C.A.R.

FINAL PHASE I
CONTAMINATION ASSESSMENT REPORT
SITE 36-8: CHEMICAL DRAINAGE DITCH

April 1987
Contract Number DAAK11-84-D0016
Task Number 1 (Section 36)
(Version 3.2)

Figure 36-8-3
REGIONAL TOPOGRAPHY
SITE 36-8
ROCKY MOUNTAIN ARSENAL

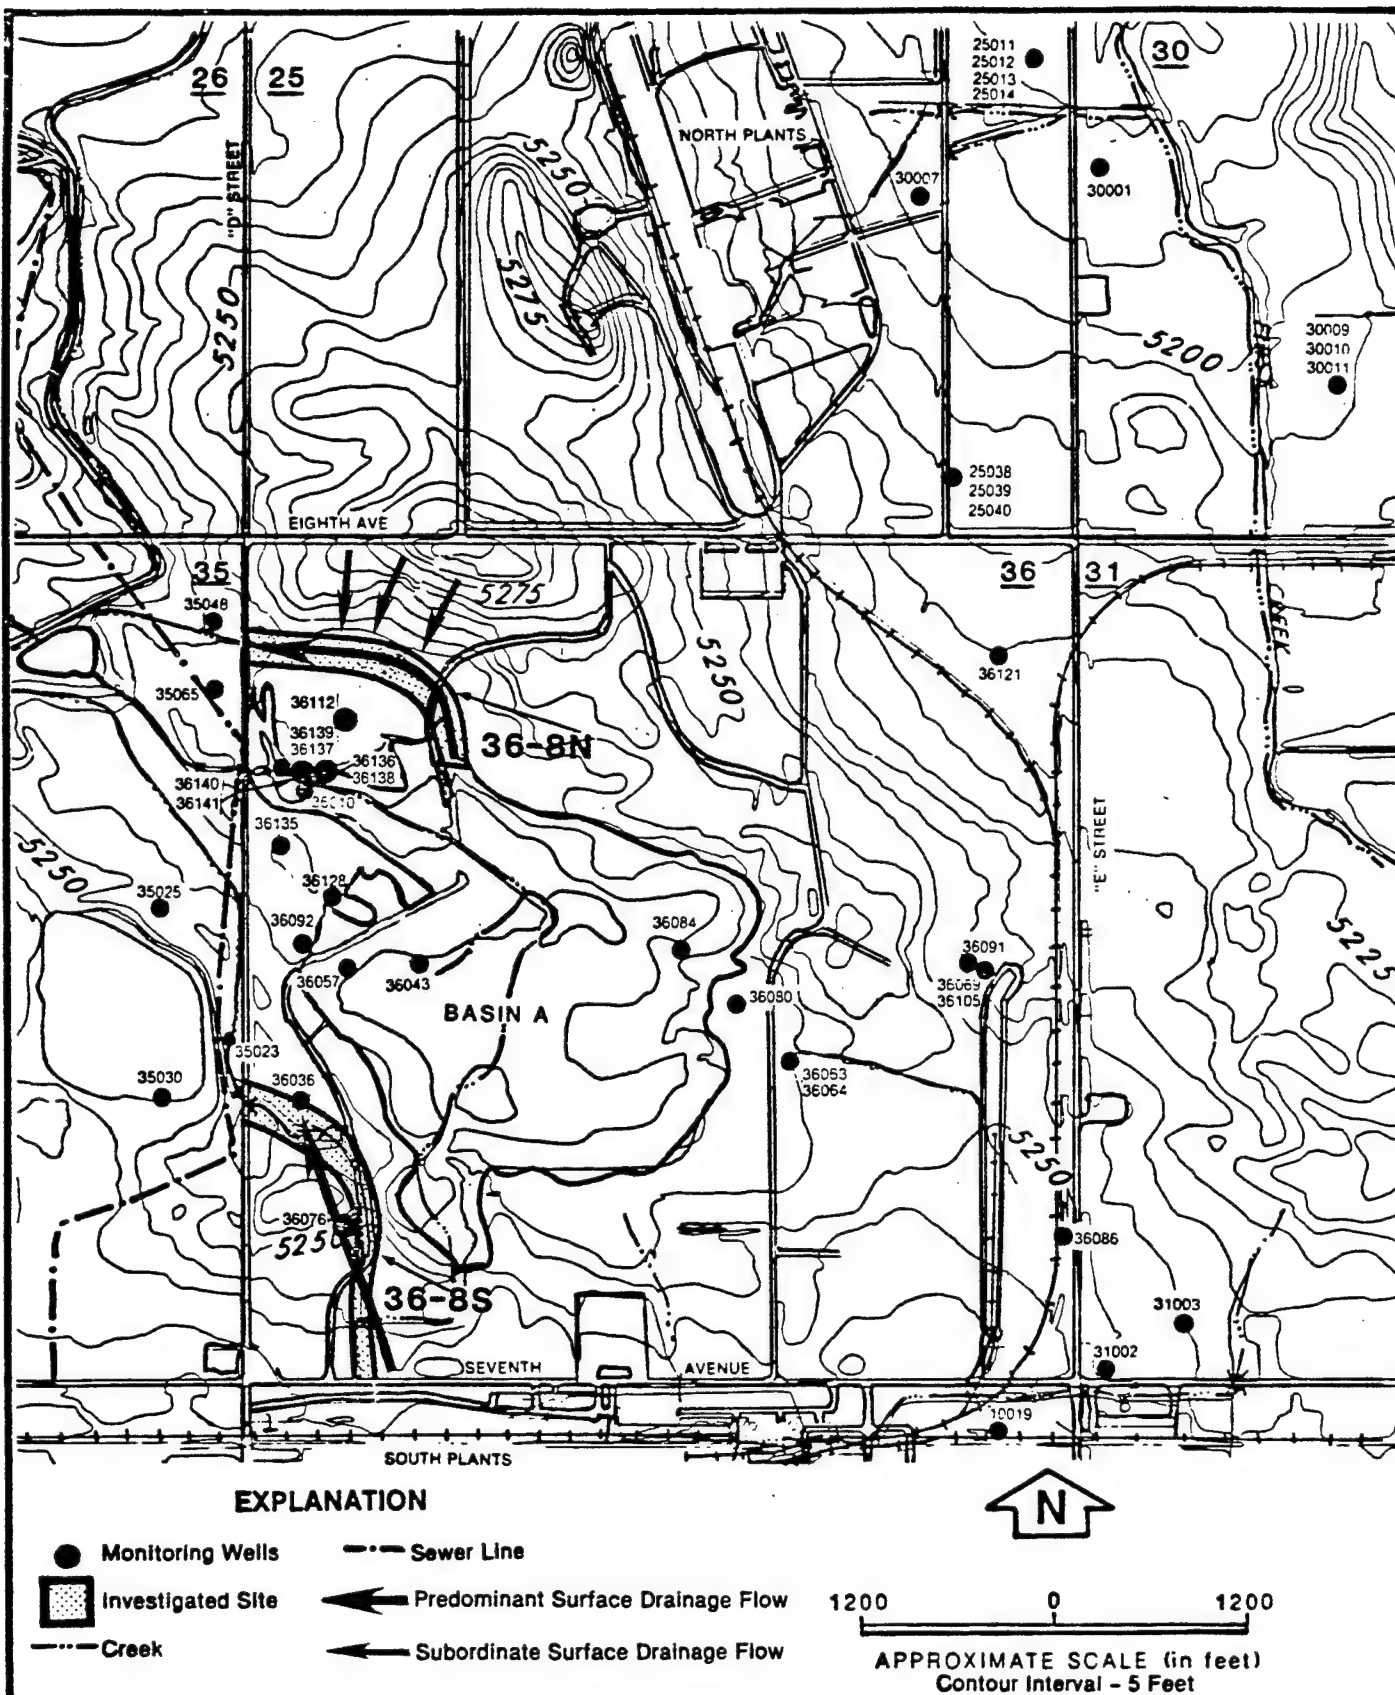
1. P.36-8-17 The monitoring well #1 location on this figure doesn't correlate with Figure 36-5-6. All monitoring wells need to be labeled.
2. P.36-8-17 Previous ground water data collected in 1979, 1983, and 1984 show substantial DBCP contamination (195 ppb) at well #1 and volatile organic contamination at well #76 yet soil samples were not collected in the vicinity of this known contamination. Phase II analytic program sampling should be conducted into the uppermost ground water system in these areas for volatiles and DBCP.

1. P.36-8-17 The monitoring well locations shown on the figures were incorrect in the previous report draft. A new Figure 36-8-3 has been included and shows the correct locations and numbers for relevant wells.

Figure 36-8-6a
SITE 36-8S, PHASE I INVESTIGATION
CHEMICAL ANALYSIS RESULTS

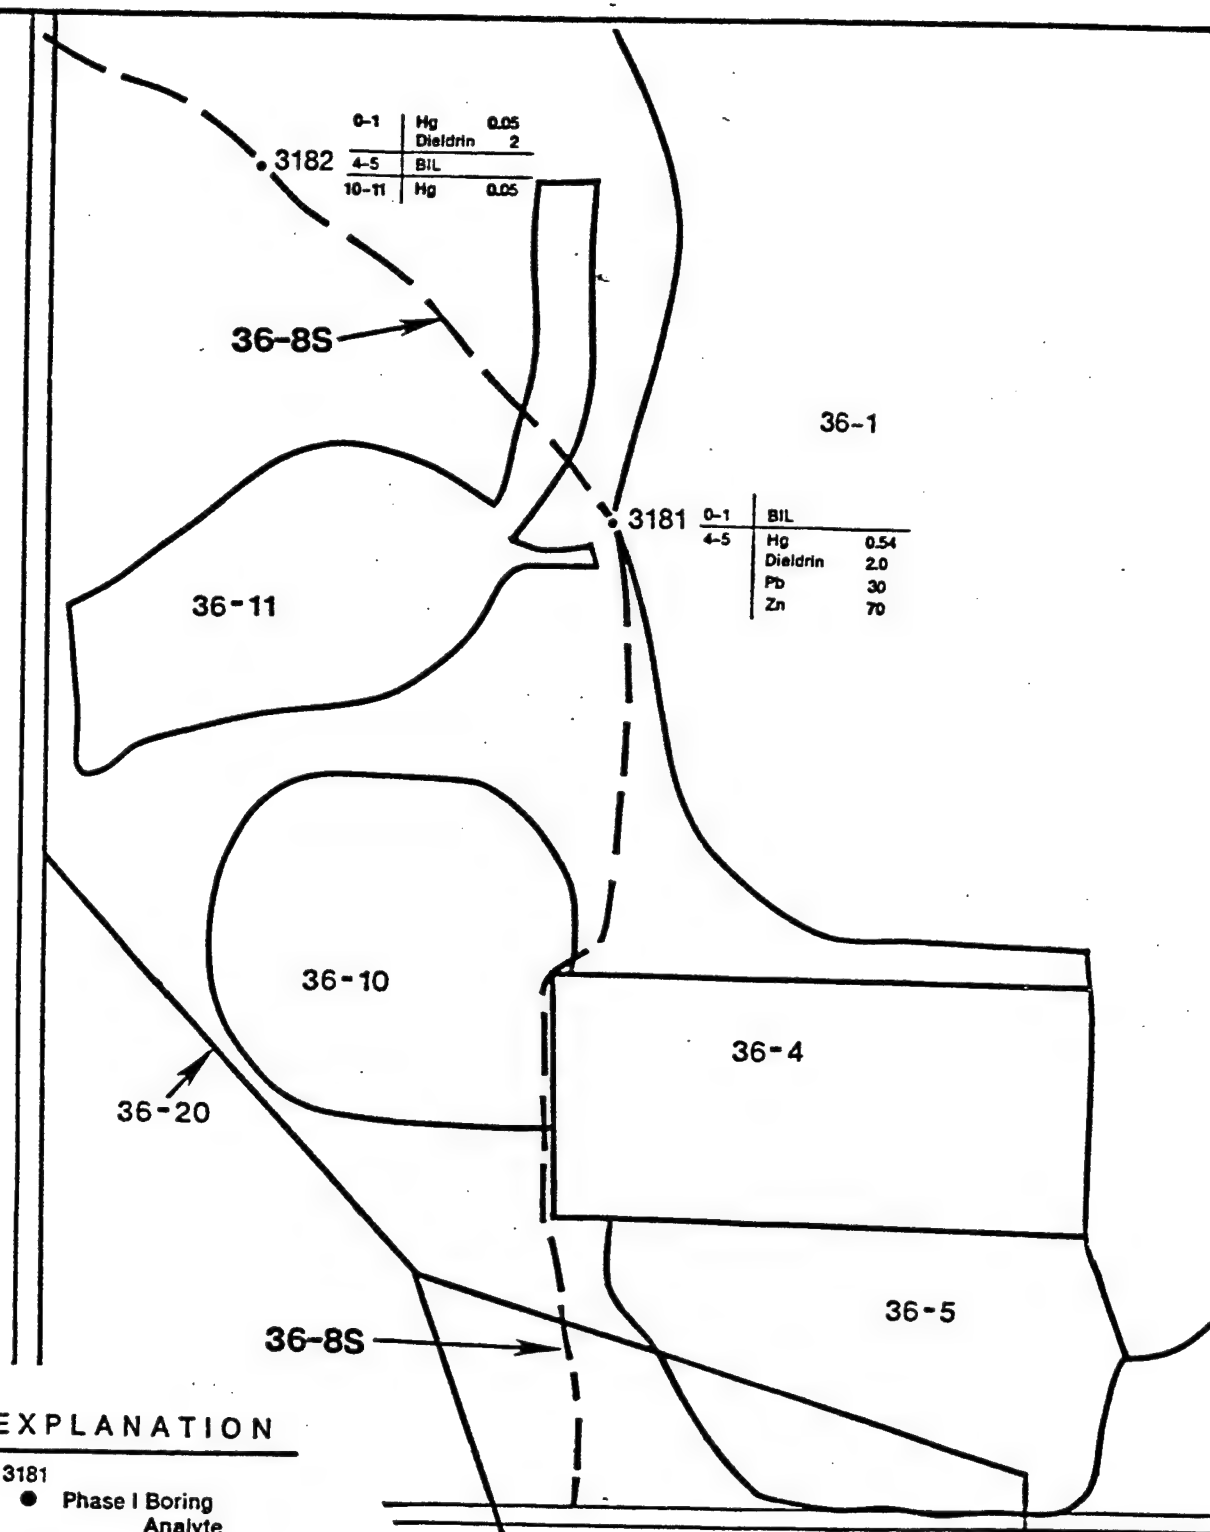
Figure 36-8-6a and Shell Comment No. 2 on Site 36-8 Draft Final CAR. The Army asserts that the "undocumented line" (see 36-20 Task 1, page 9) is being investigated as a part of Task 10. This line was not originally a part of Task 10, and no formal proposal to add this work to Task 10 has ever been received for review. Shell requests that Army provide the relevant documentation for review.

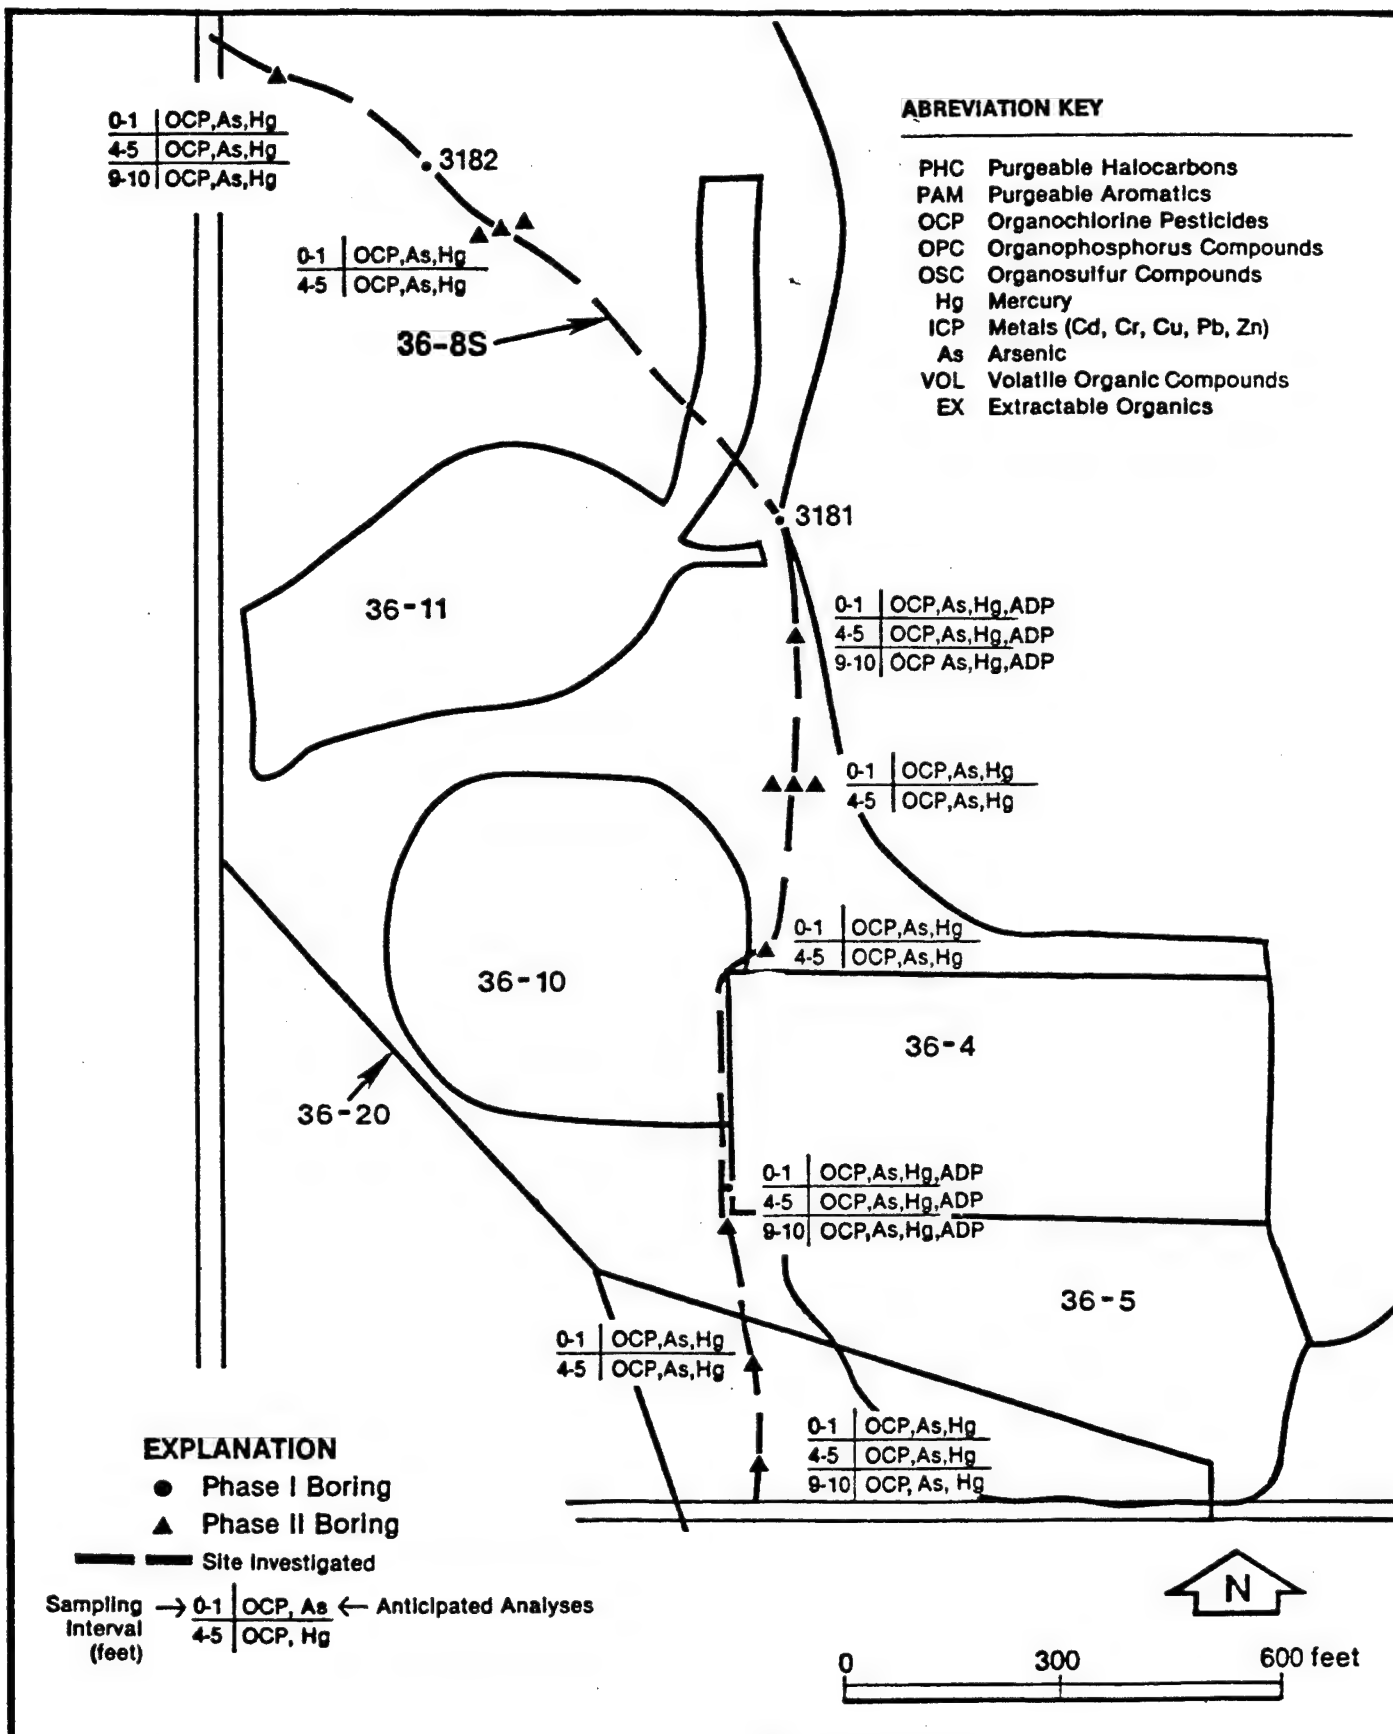
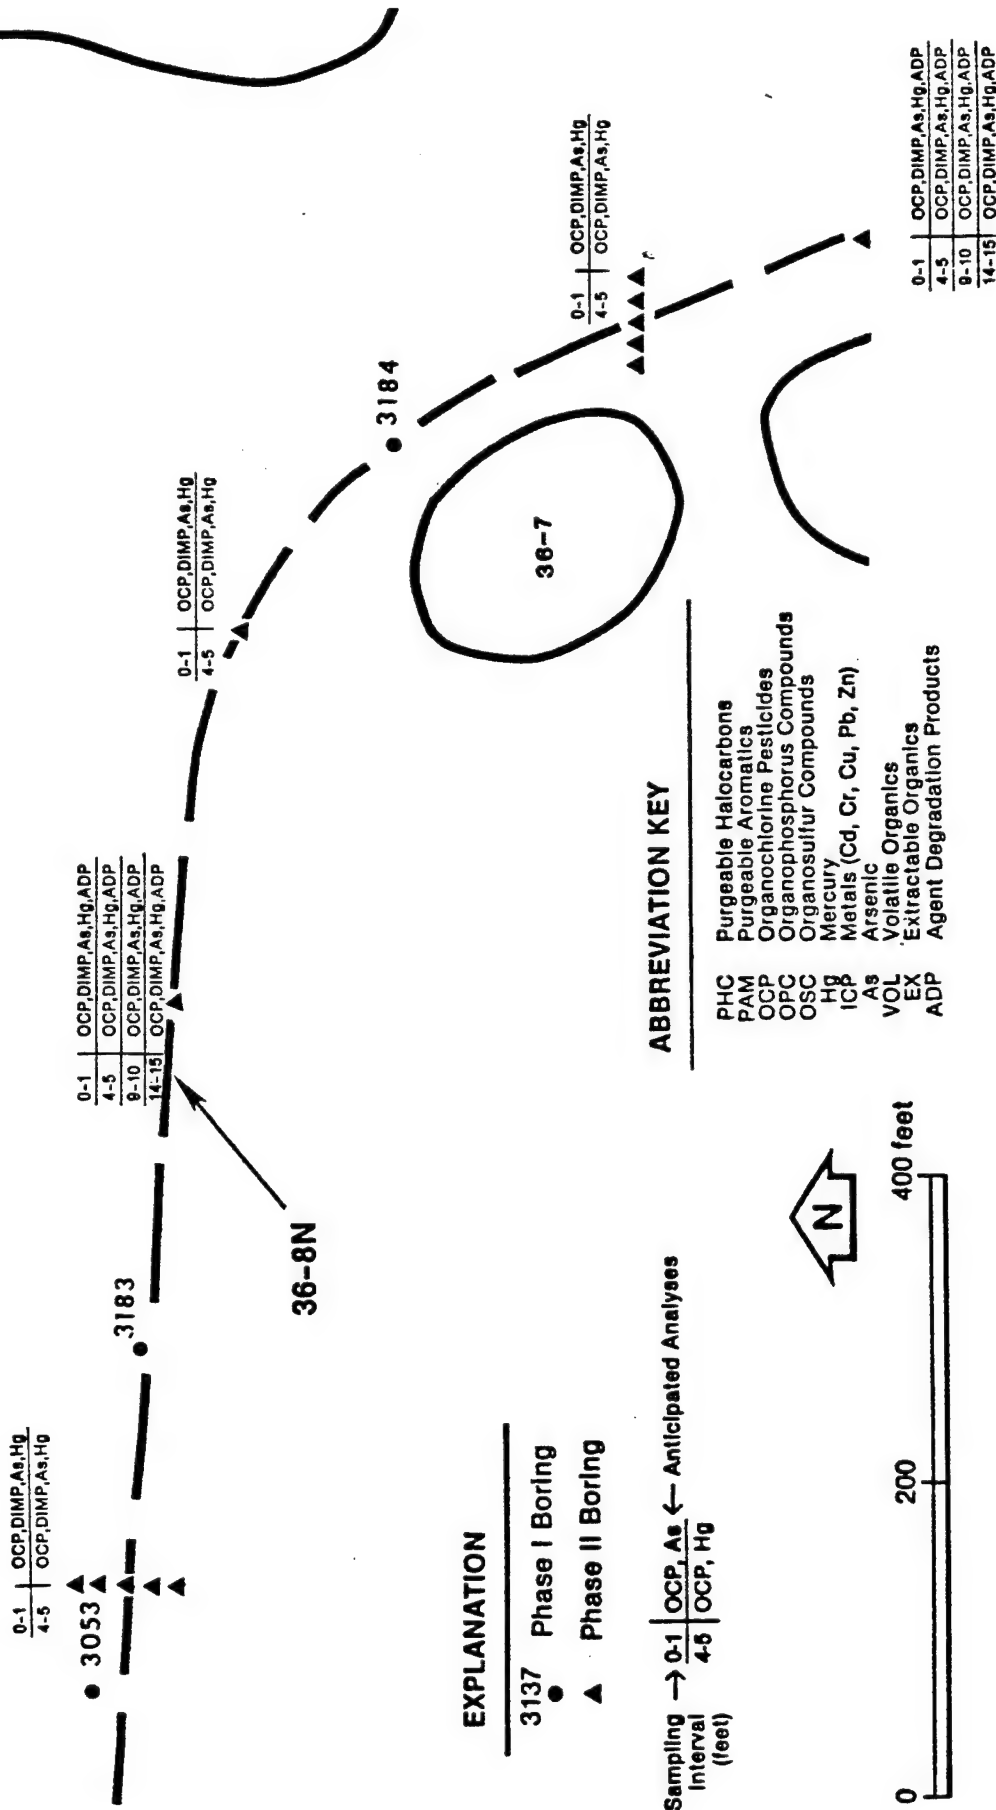
2. Figure 36-8-7. Boring 3185 should be on this figure. Borings should be placed around 3185.
3. Figure 36-5-1. Volatile analyses are done on all sample intervals except A in source areas 36-8 and 36-20 and on C level (or deepest) in 36-5, 36-10 and 36-12. What are the criteria for deciding which sample interval will be analyzed for volatiles?
4. 36-8-9. Will contamination above or in the gray lime cake be investigated?
5. Table 36-8-5. Wells listed are not identified in Figure 36-8-5a.
6. 36-8-19, first paragraph The suggestion that the contaminants are derived from disposal activities associated with source 36-8 may be true provided fluctuation of the ground water table does not exceed a couple of feet.

2. Figure 36-8-7. Boring 3185 was part of the 36-20 investigation and was mislocated in the field, off the 36-20 alignment. Phase II borings for Site 36-20 are located in this vicinity. Boring 3185 is influenced by an abandoned sewer line nearby, which is being investigated under Task 10.
